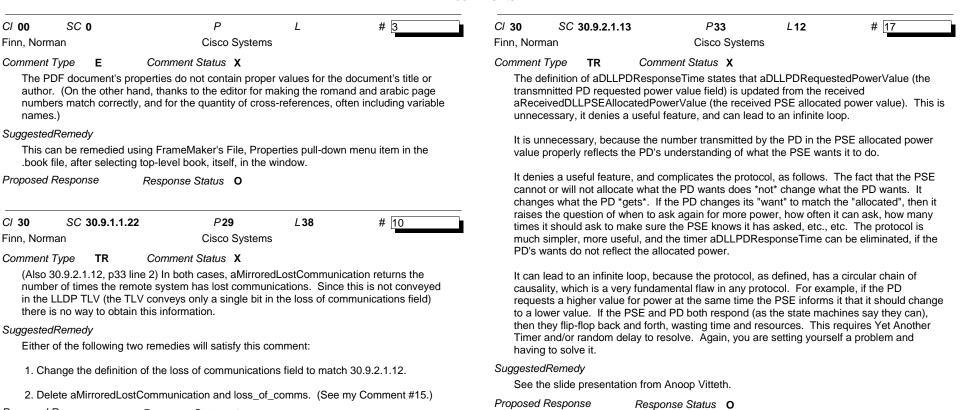
The method of interoperability between "new power TLV" implementations and "old power TLV" implementations is completely lacking, except for the "don't transmit both" injunction in 33.6. As mentioned in another comment, this is a serious flaw in the draft.

At present, the draft demands either a forklift upgrade of all systems, configuration in one system of the old/new capabilities of the neighboring system, or non-standard, unspecified, and therefore non-interoperable actions by the different implementations.

At a minimum, the interoperability scenarios between 802.3at-capable and 802.1AB-2004capable systems must be defined, if 802.3at is to be successful. A non-normative appendix describing how 802.3at relates to the extremely limited capabilities of the widelydeployed TIA TR41 LLDP-MED standard would be very useful, and relatively easy to generate.

Given the suggestion for combining the 802.1AB power TLV and the 802.3at power TLV contained in my comment #1, .3at power can be combined fairly easily with .1AB power. When an 802.3at PSE implementation is receiving only the 802.1AB-2004 power TLV from the PD, it uses the power class field from the old TLV and Table 33-10 of 802.3af, instead of the (new) PD requested power value field, to determine the value for aMirroredDLLPDRequestedPowerValue, and otherwise uses the new state machines. Similarly, a PD uses the (old) power class field and 802.3af Table 33-10 to determine aMirroredDLLPSEAllocatedPowerValue. aMirroredLostCommunication is never set.

(There may be other ways to remedy this issue.)
